14MP
14 Milton Place
Gravesend
DA12 2BT
Kent

Interior refurbishment
Listed Building Consent 20250269

Details showing how the insulation boards will be installed in relation to the skirting boards and architraves.
Sash windows with architrave:
-Bedroom 1, 2, 3, 4
-Kitchen
-Reception room

14MP11/PR

Detail D
Sc.1:2.

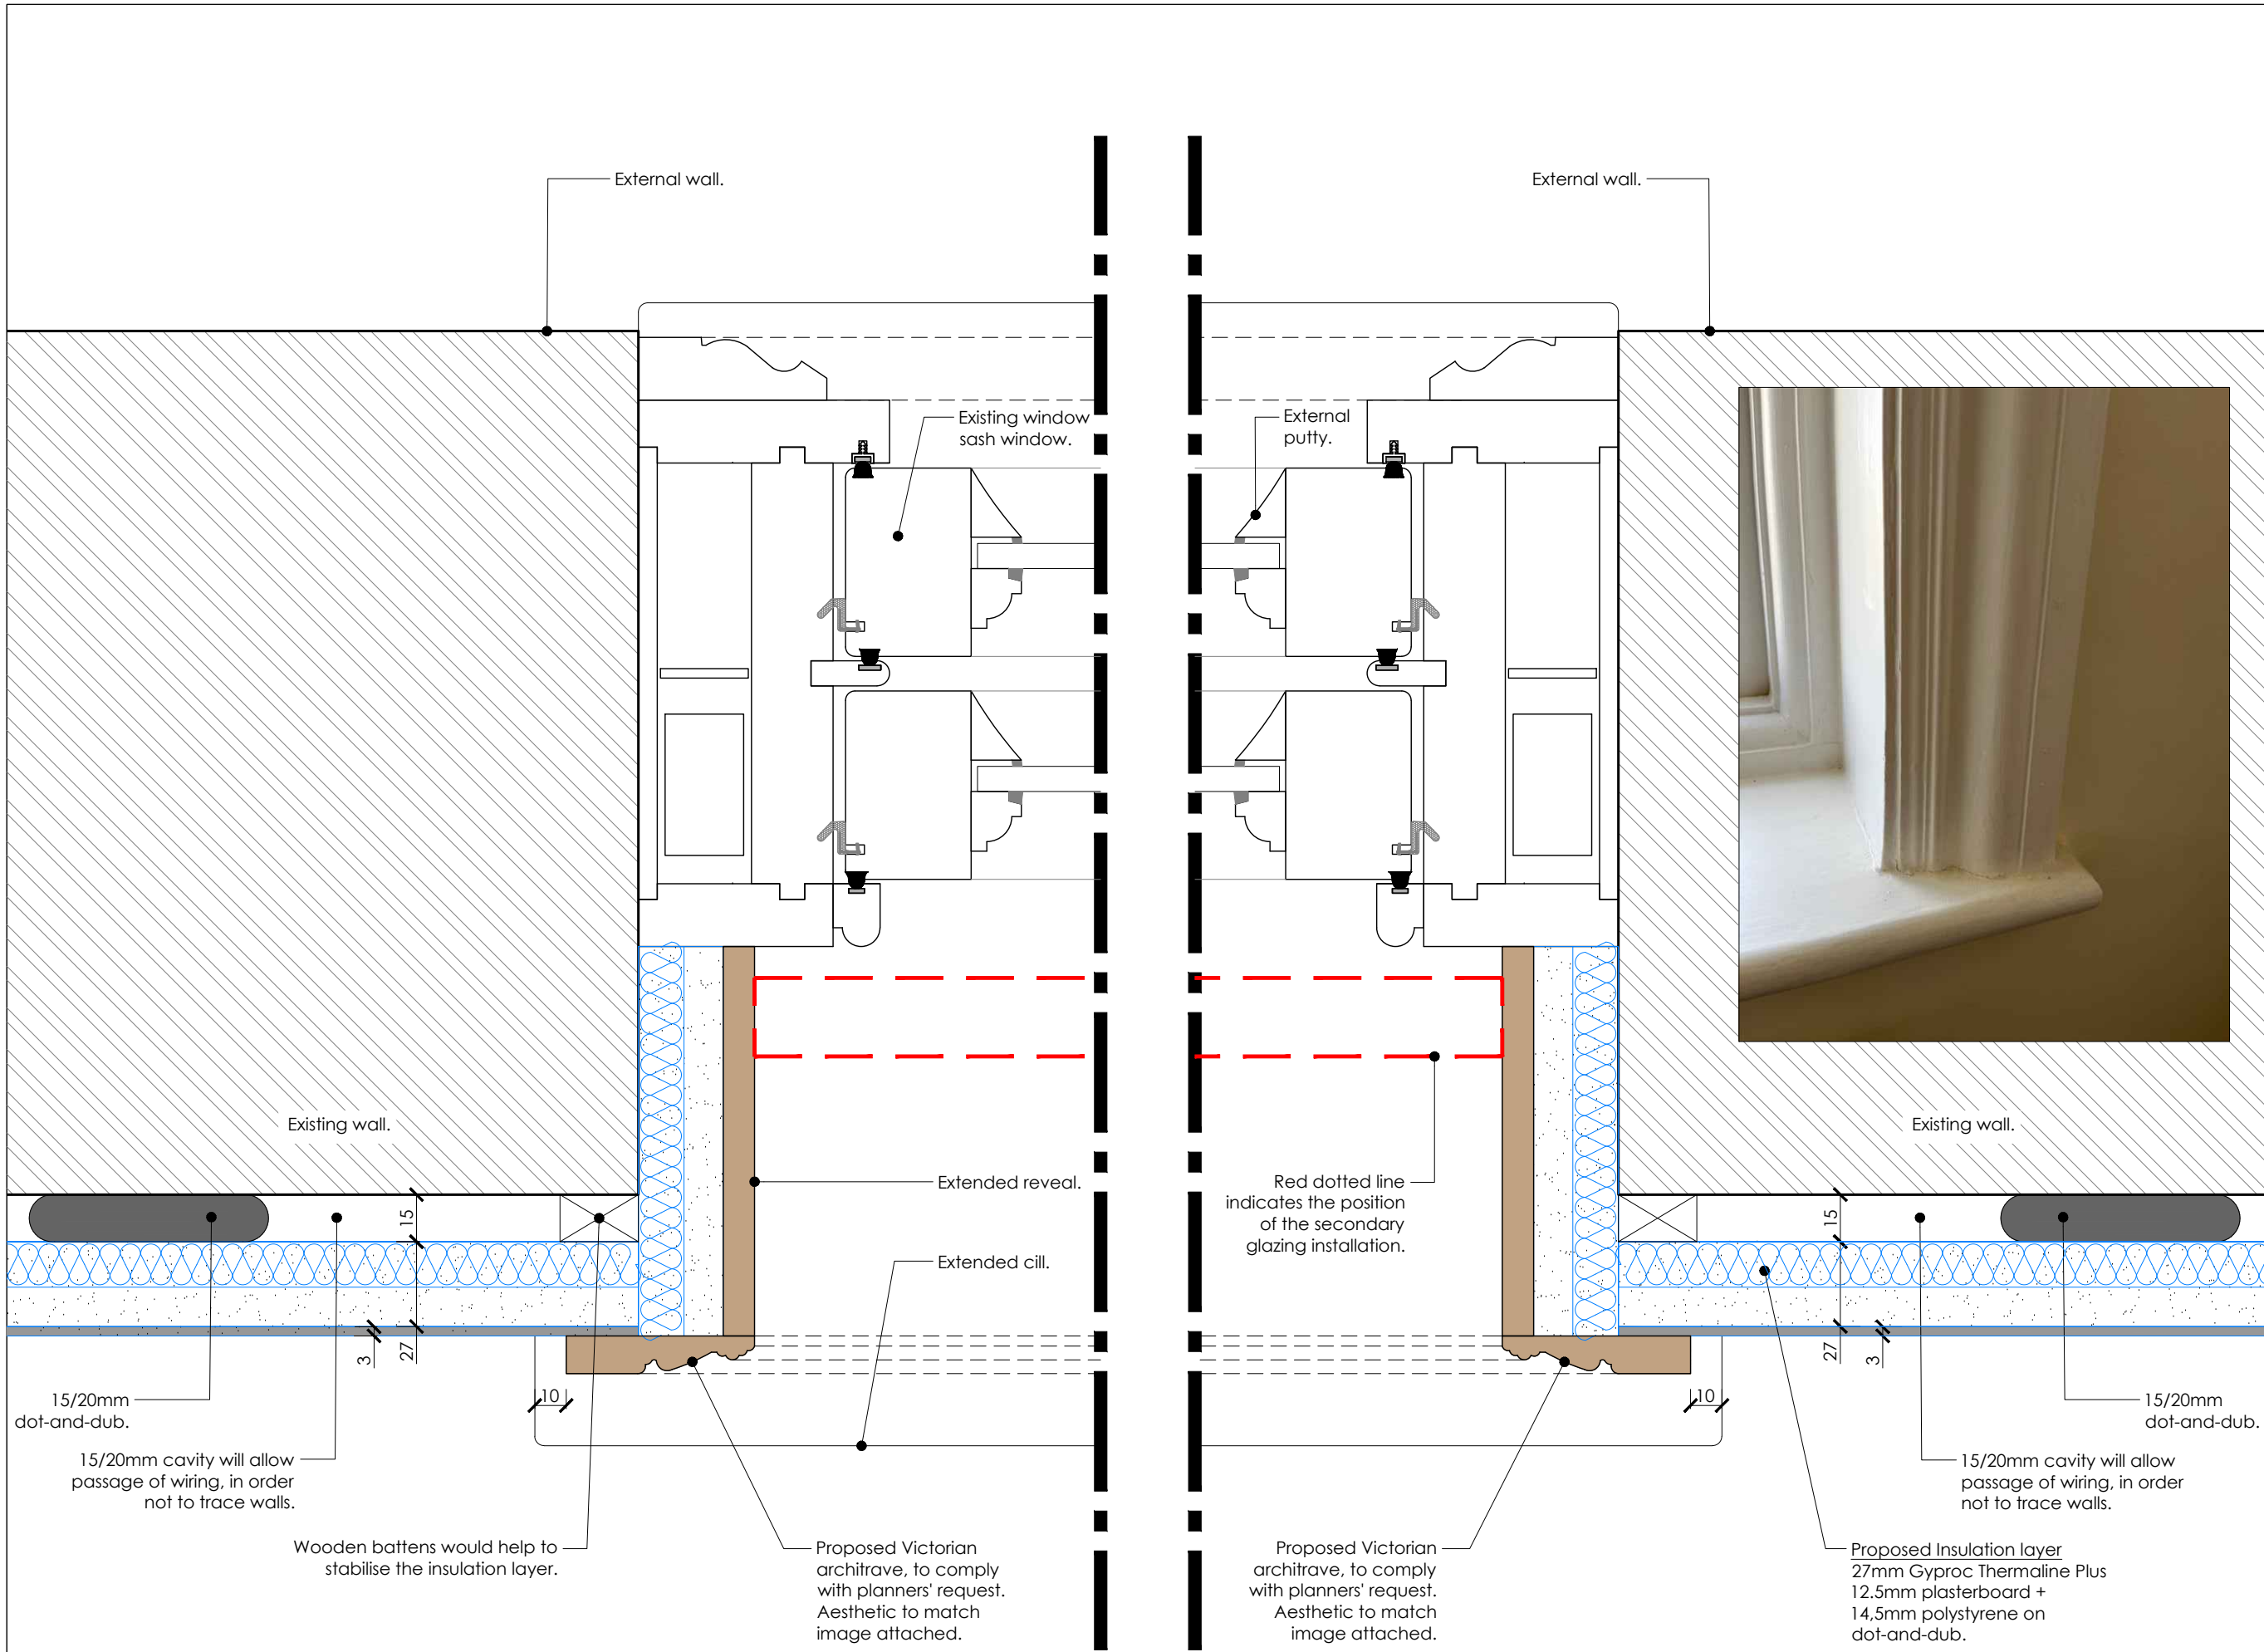
- Window's reveals adjusted by extending the window cill and reveal board with an Victorian architrave.
- Proposed new Victorian skirting board , as per planners' suggestion.

- Windows architraves' setting amended as per planners' request.
- Architrave to be added also to Bedroom 2, 4 and Reception room.

- Windows details amended to reflect existing section.
- Secondary glazing details and notes for reference.
